SERVICE BULLETIN

ENGINE - FUEL AND CONTROL - TO PROVIDE A NEW ELECTRONIC ENGINE CONTROL (EEC) WITH THE
SN11 SOFTWARE CONFIGURATION - CATEGORY CODE 3 - MOD.ENG-73-0065

V2500-ENG-73-0065

Location of Electronic Engine Control (EEC)
Fig.1

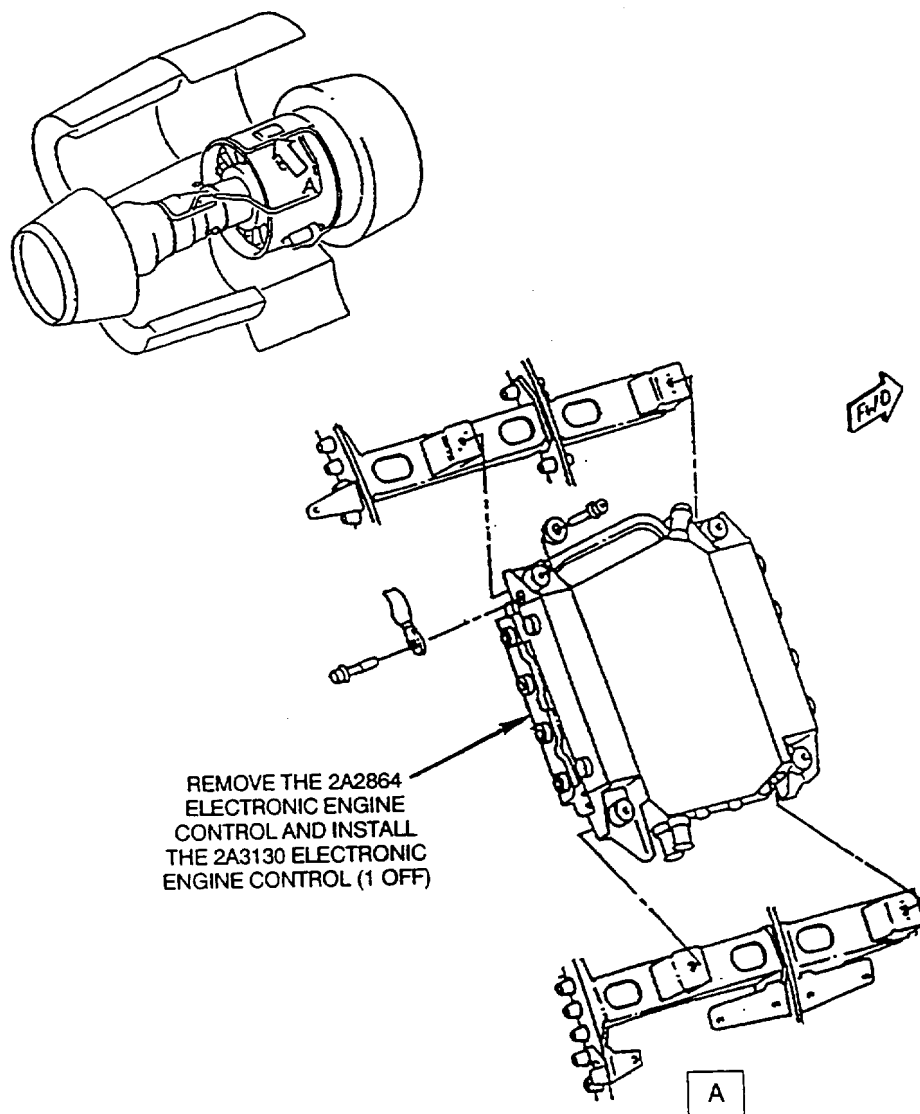
- (1) Remove the 2A2864 Electronic Engine Control by the approved procedure given in Reference (1), Chapter/Section 73-21-34, Removal/Installation. Refer to Figure 1.

- (1) Install the 2A3130, Electronic Engine Control (1 off) by the approved procedure given in Reference (1), Chapter/Section 73-21-34, Removal/Installation. See Figure 1.
